2.1.3 AMENDMENT 3: CPW

Additional smoke vent equipment to CPW level 09 roof

APPROVED ELEVATION
Drawing: 19555-CPA North Elevation

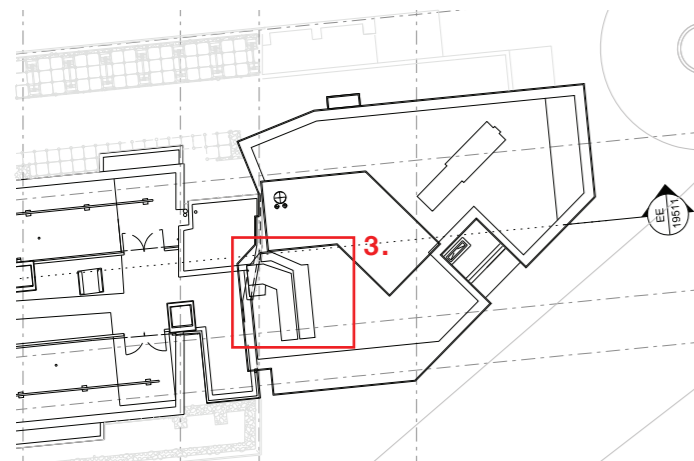
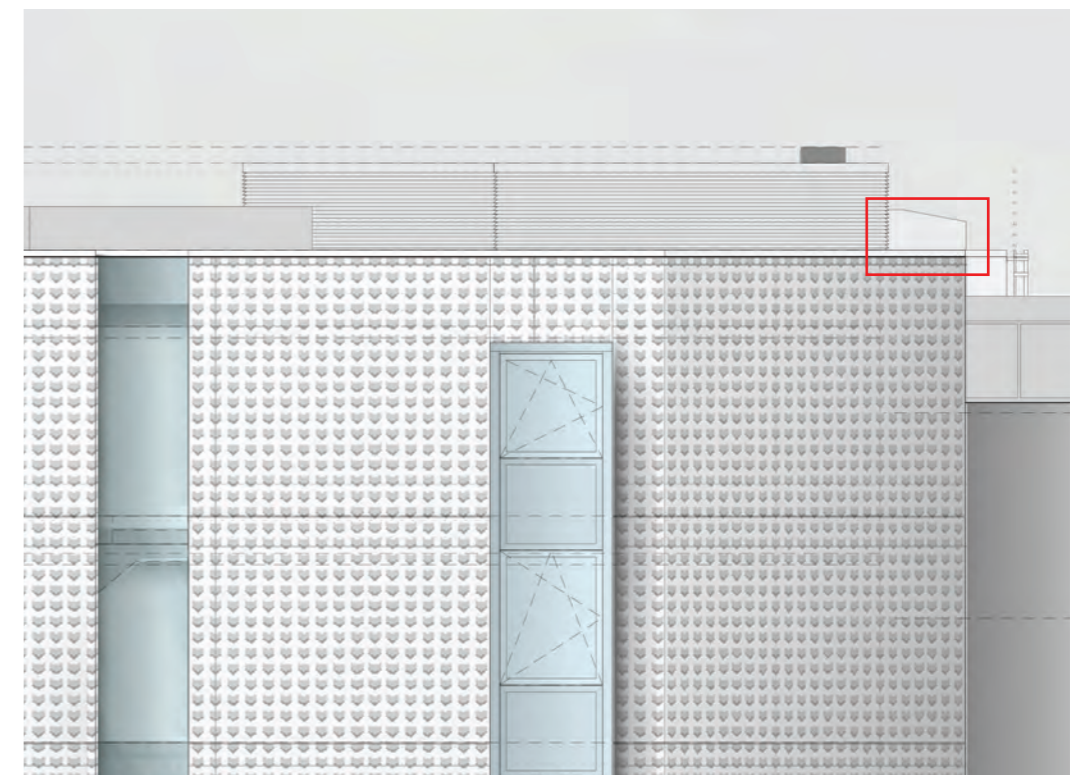
Where the new CPW affordable housing abuts the existing CPH residential block, the current permission allows for removal of existing glazing bays to the South stairwell. These are to be replaced with a solid Party Wall construction incorporating a new smoke and extract vent shaft. This shaft serves the existing residential lift lobbies, communal laundrettes and the lift plant room.

Further detailed calculations have determined the need for 3no. additional rooftop extract units. Initial investigations considered locating these on the South end of CPH existing roof but the area available was heavily restricted by the need to maintain access and would result in a visually obtrusive location visible from below. It is therefore proposed to locate these on top of CPW level 09 roof as this reduces duct routes to a minimum and ensures, the units are concealed from street view behind the adjacent roof parapets. The uppermost level of the units will be +58.897 AOD.
